Drinking Water Audit Report

County:	Cavan	Date of Audit:	8 July 2019
Plant(s) visited:	Swanlinbar Water Treatment Plant	Date of issue of Audit Report:	15 July 2019
		File Reference:	DW2013/36
		Auditors:	Derval Devaney Daryl Gunning
Audit Criteria:	<ul style="list-style-type: none"> • The <i>European Union (Drinking Water) Regulations 2014 (S.I. 122 of 2014)</i>, as amended. • The <i>EPA Handbook on the Implementation of the Regulations for Water Services Authorities for Public Water Supplies</i> (ISBN: 978-1-84095-349-7). • The recommendations specified in the <i>EPA Drinking Water Report</i>. • EPA Drinking Water Advice Notes No.s 1 to 15. • The recommendations in the previous EPA audit report dated 10th May 2013.

Photo 1 Sludge floating on clarifiers surface and dirty channels

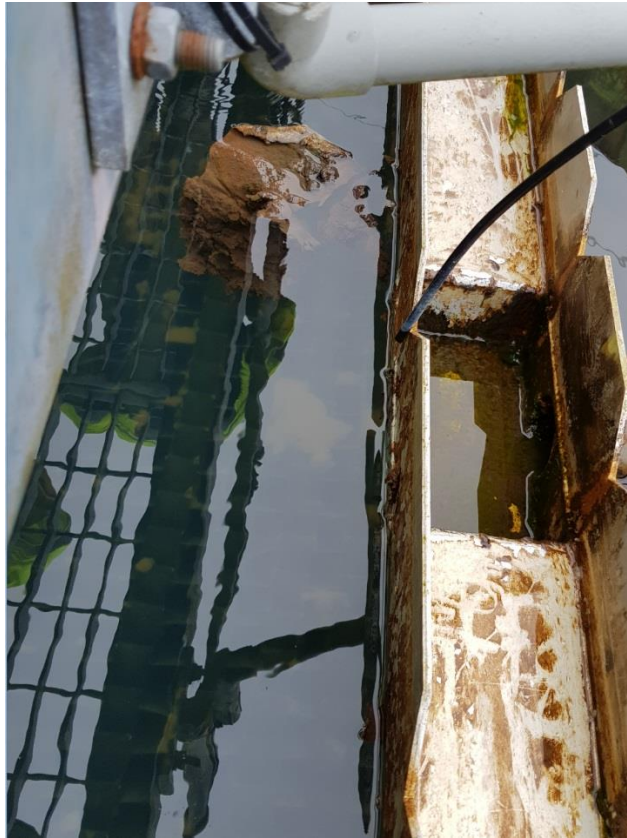
3. Irish Water should undertake the following actions to ensure better management of the clarification process at Swanlinbar water treatment plant:
 - a) ensure the settled water outlet channels in the clarifier are cleaned on a regular basis to prevent build-up of sludge on the channels and internal walls of the clarifier;
